IN REPLY REFER TO:
3590
UTU-78187
(UT-923)

Re: Further information required for the Mining Plan Modification Request at the Koosharem Clay Pit, Federal Lease UTU-78187.

Enclosure Approved Pit floor Profiles

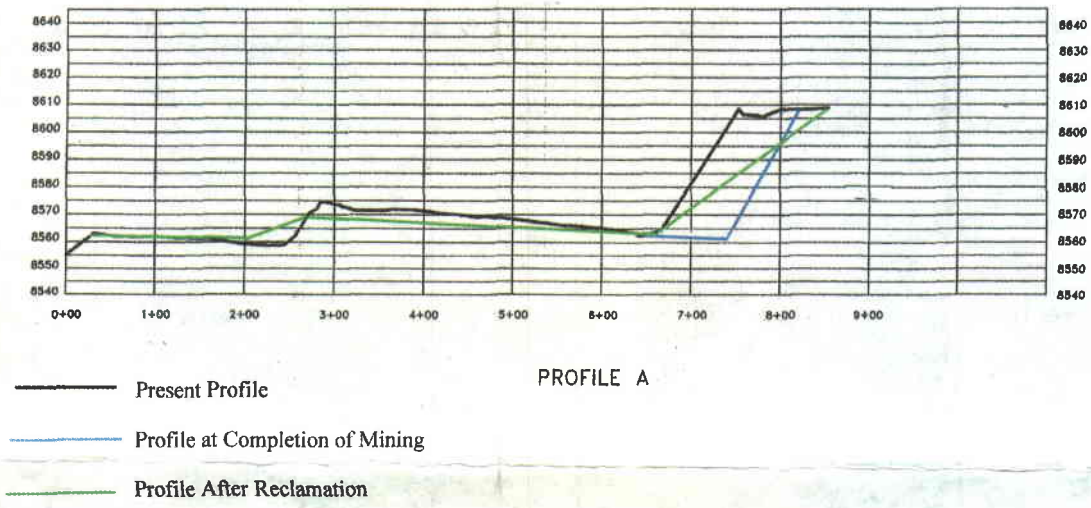
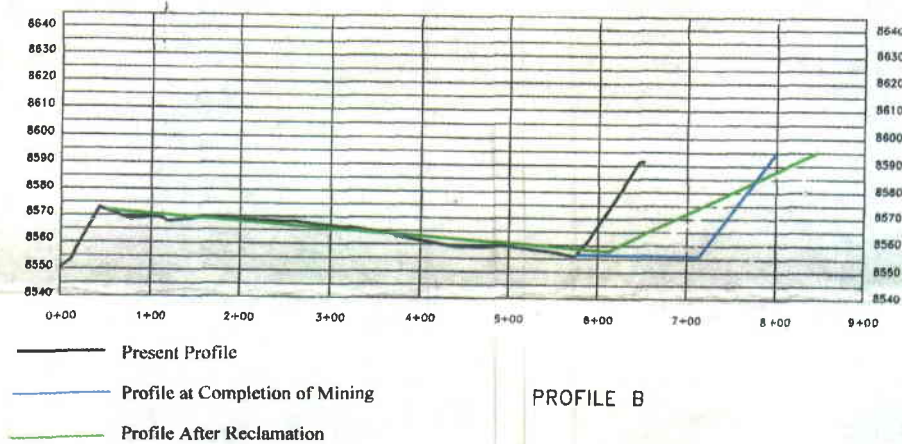
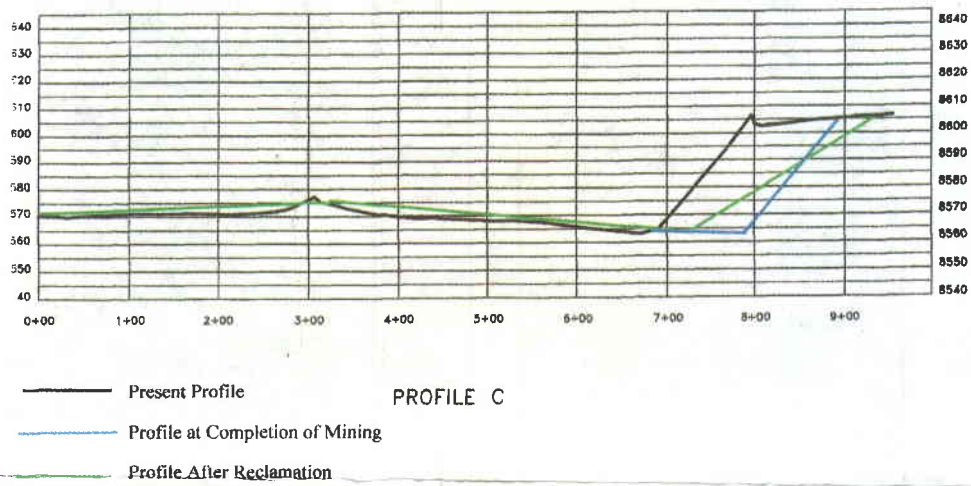
1. The pit floor profiles (enclosed) show that the pit on the west side (left side of the profile) will not have any additional mining conducted in this area. In order for BLM to approve the mining of Area "A" and Area "B" as shown on the map that was submitted as part of your request, you must submit a new mining pit floor profile that shows the existing Lower Box Creek road and the berm/barrier along with the proposed depth of the pit. The proposed depth of the pit must have a geologic basis which should be made part of your response. Geologic cross-sections are required in order to verify these projections.
2. The pit slope during mining must be addressed along with the access in and out of the pit. A narrative along with a map will be required. If benches are planned, then details of the bench configuration must be addressed and cross-sections must be provided.
